WATER PERMIT NO. 7140-3

Application For Permit To Appropriate Water Within The State Of South Dakota

**RECOMMENDATION OF CHIEF ENGINEER FOR WATER PERMIT
APPLICATION NO. 7140-3, Denis Mikkelson**

REPORT ON
WATER PERMIT APPLICATION NO. 7140-3
Denis Mikkelson
June 4, 2009

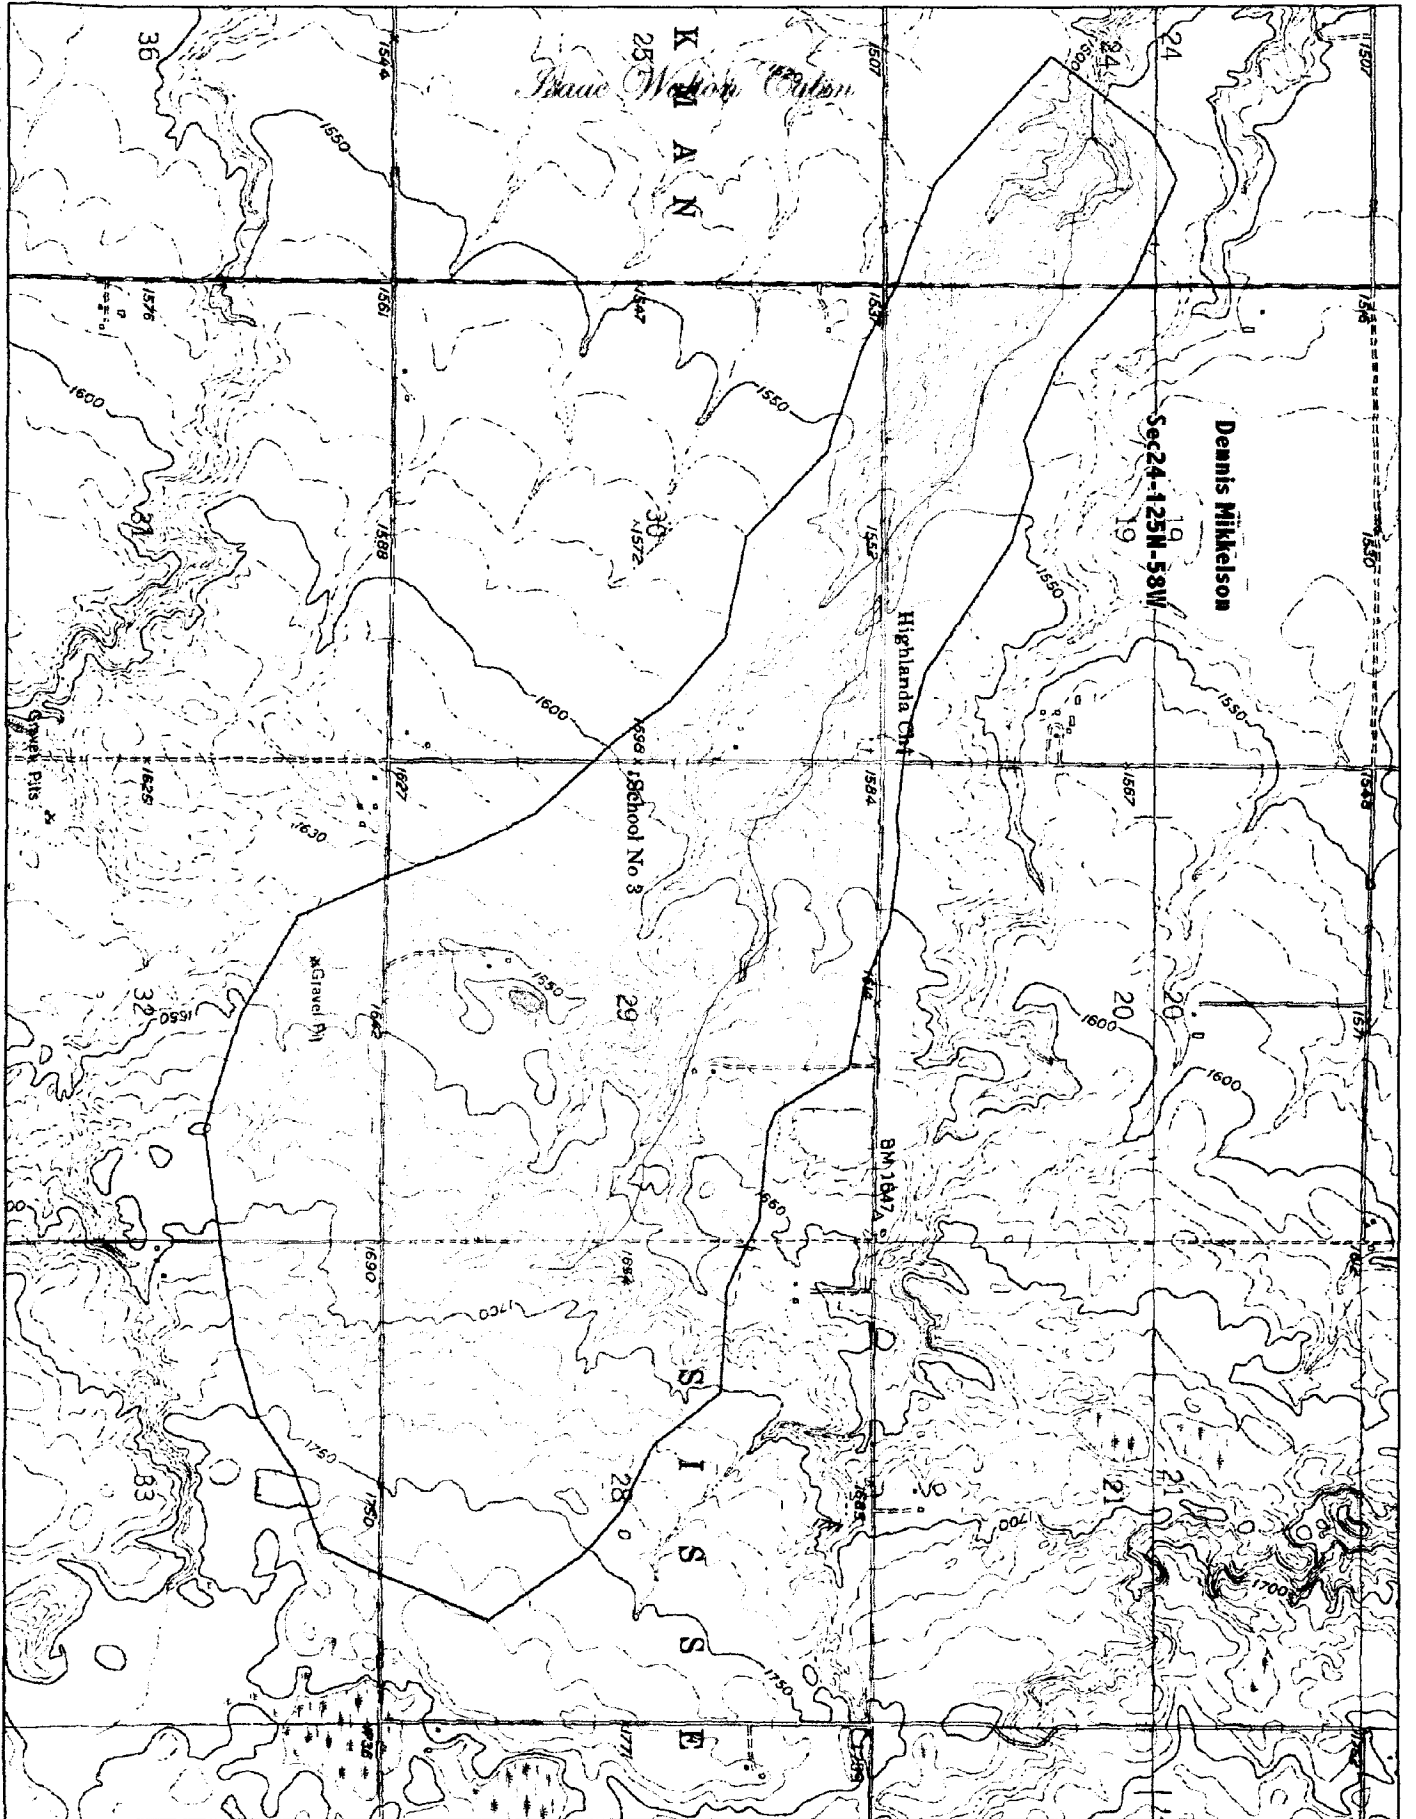
Top of Dam Elev. - 85
 2nd Spillway Elev. - 82
 P. Spillway Elev. - 78
 D/S Emb. Top Elev. - 62.2

Cat. 3 - Low Hazard Dam

Ht. = 22.8 ft.

Normal Storage Capacity = 47 Ac-Ft
 Int. Storage Capacity = 76
 Max. Storage Capacity = 103.5

Int. Capacity x Eff Ht. = 76 x 20 = 1520 < 3000 ∴ 25 yr
 Minimum Spillway Design

1. Topo Map - OK
2. Dam Axis Profile - OK
3. Dam Max X-Sec. - OK
4. Area Capacity - OK
5. Outlet Details - OK
6. Spillway Rating - OK
7. Spillway Details - OK
8. Specs. - Std NRCS - OK
9. EPP - N/A Cat. 3 - OK
